TSB	Model	OPTIMA(TF) (ALL)
	Group	Body Electrical System (92)
	TSB No.	KFE12-92-P020-TF
Subject OPTIMA (TF) AUDIO DISPLAY MALFUNCTION REPAIR	TSB Type	Field Fix
	Published	2012-02-21
	Area & Distributor	Asia, Pacific, South America, C. America, West Europe, East Europe, Middle East, Africa

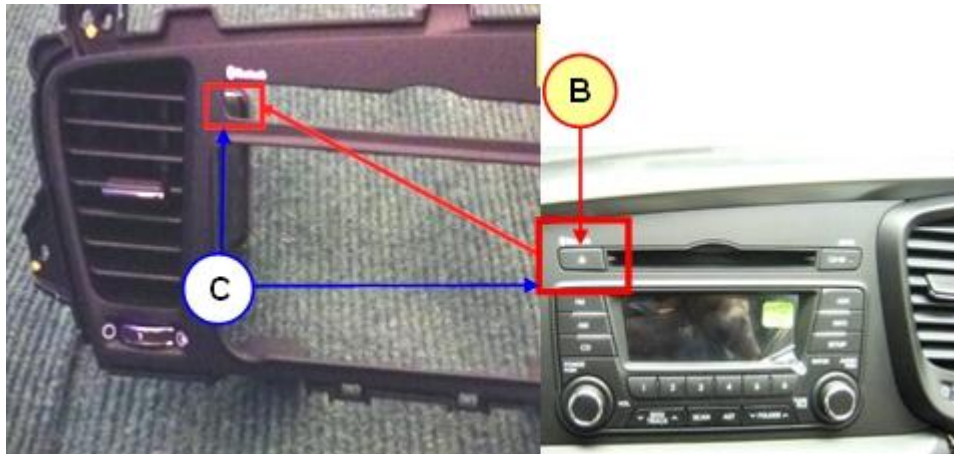
On some Optima (TF) RHD vehicles equipped with CD player audio the “CD-IN” icon (A) might be intermittently indicated on the audio display although no CD is inserted

The eject button (B) does not return completely due to the interference with the center fascia upper panel (C).

Only for the vehicle exhibiting the condition mentioned above cut the interference part of the center fascia upper panel following the Service Procedure to repair this concern.

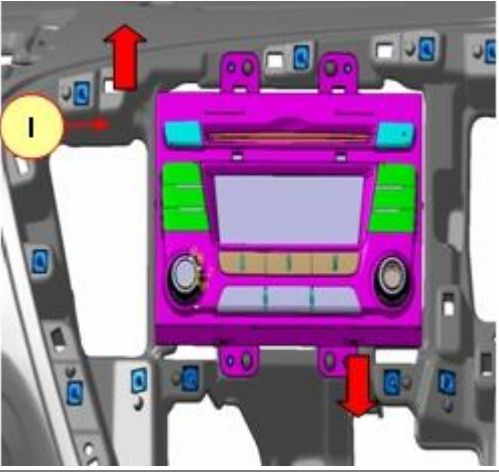
8. Using a cutter cut out the interference part (H) from the center fascia upper panel, where blue marking indicates in the right picture.

9. Lightly loosen all the audio mounting screws without removal. 10. Raise the upper left corner of the audio and lower the lower right corner as much as possible, and then completely refasten all the screws. # I : Audio 11. Reinstall the center fascia upper panel and check that the CD injector button returns normally without any interference.	
12. Reinstall all the removed components in reverse order of removal.
